RE: **323 Jefferson Apartments**
323 Jefferson SE
Grading Plan Stamp Date: 2/28/19
Hydrology File: K17D116

Based on the submittal received on 3/6/19 the above-referenced Grading Plan cannot be approved for Building Permit until the following are corrected:

GRADING & DRAINAGE PLAN

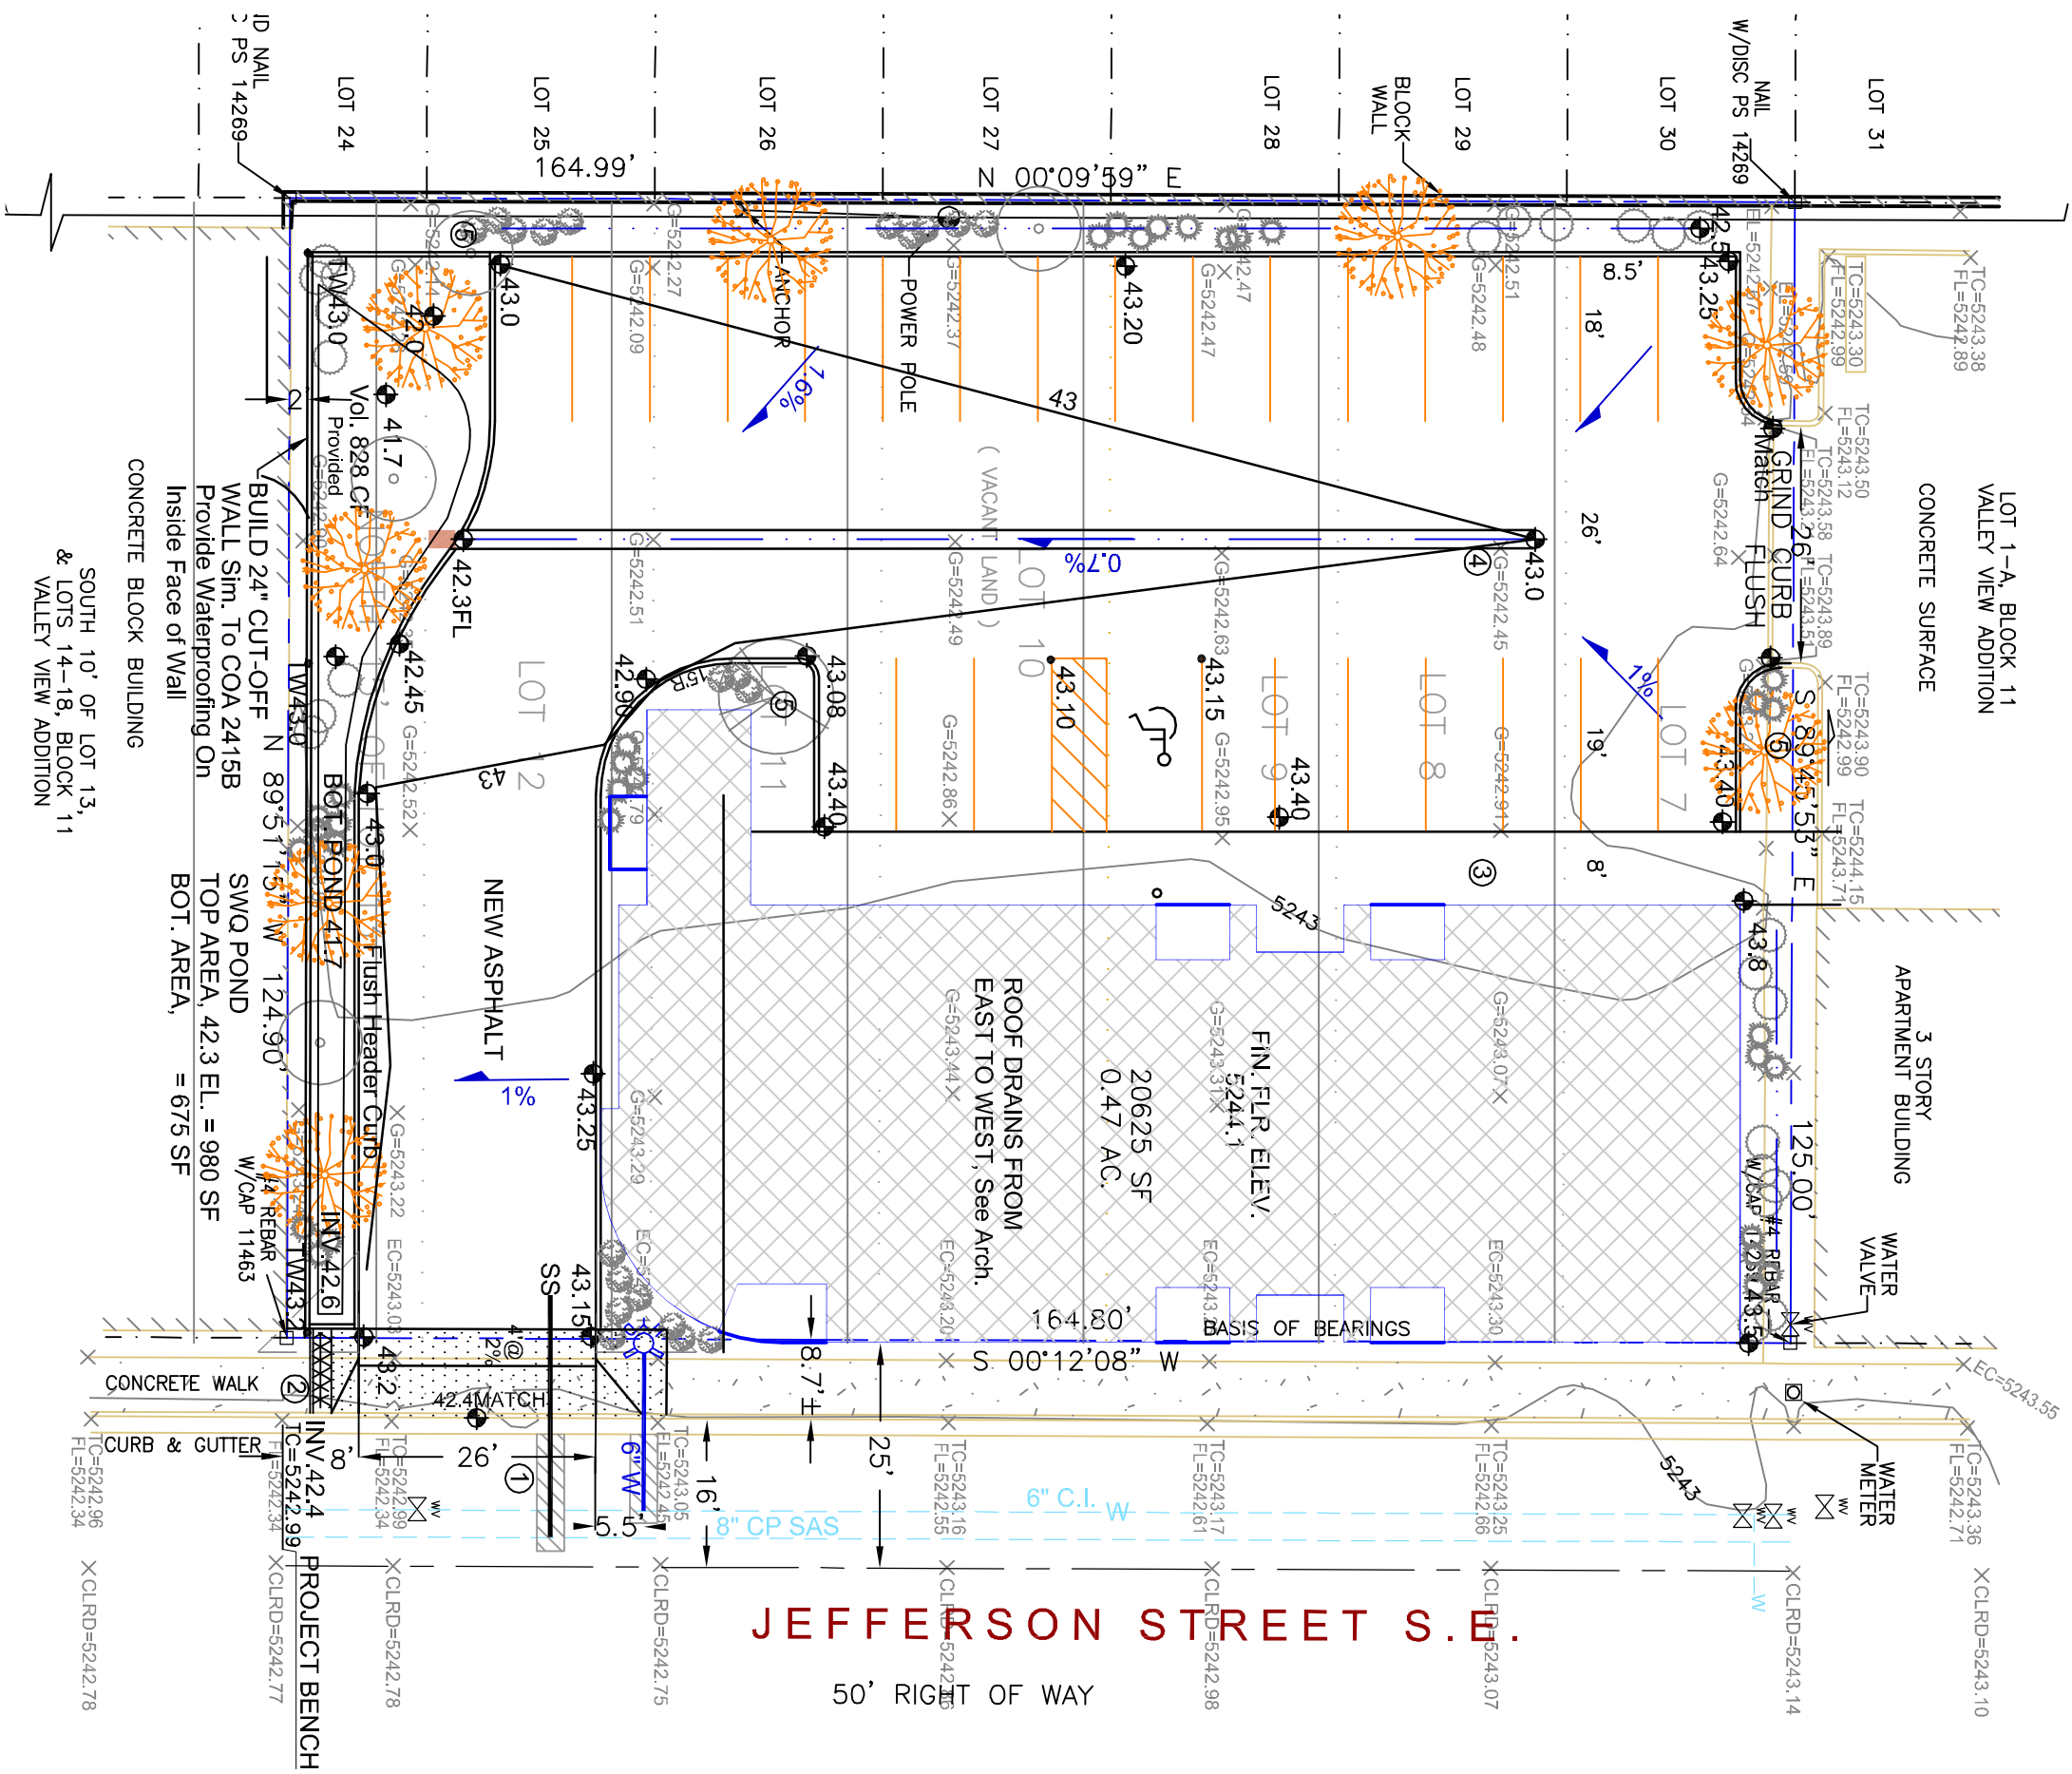
1. Provide a section through the west property line showing the grades on both sides of the property line and existing wall. Provide existing and proposed spot elevations along the property line. No additional fill may be placed against the existing wall.

2. Show the 100-yr Water Surface Elevation and the Storm Water Quality WSE. Ensure 1' freeboard is maintained along the south and west property lines, determined from the Q100 WSE. Because the sidewalk culvert invert is at 42.6' the Storm Water Quality WSE is 42.6', not 42.3'.

3. Provide a section through the pond and south property line and adjoining building. Special care needs to be taken here to ensure no water or saturated soil ponds against the adjacent building. A buried, waterproofed retaining wall/floodwall is likely needed to keep from damaging the adjacent building and get the pond to overflow to Jefferson via the sidewalk culvert. A cutoff wall with no footer is not acceptable, the retaining wall needs to be designed for saturated conditions and provided in the resubmittal. The type of waterproofing material must be specified.

4. Provide hydraulic calculations for the sidewalk culvert (primary outfall), sized for the 100-yr peak inflow; provide pond volume and routing calculations for the Stormwater Quality Volume and 100-yr storm. The weir equation with coefficient "C" =3 for a broad-crested weir must be used, not the orifice equation.

5. The pond will also need an emergency overflow sized for the 100-yr peak inflow, or you could provide 2x capacity on the sidewalk culverts. The driveway transition slab cannot encroach on the sidewalk culverts. Use the current SO-19 notes, as found on the Hydrology website.
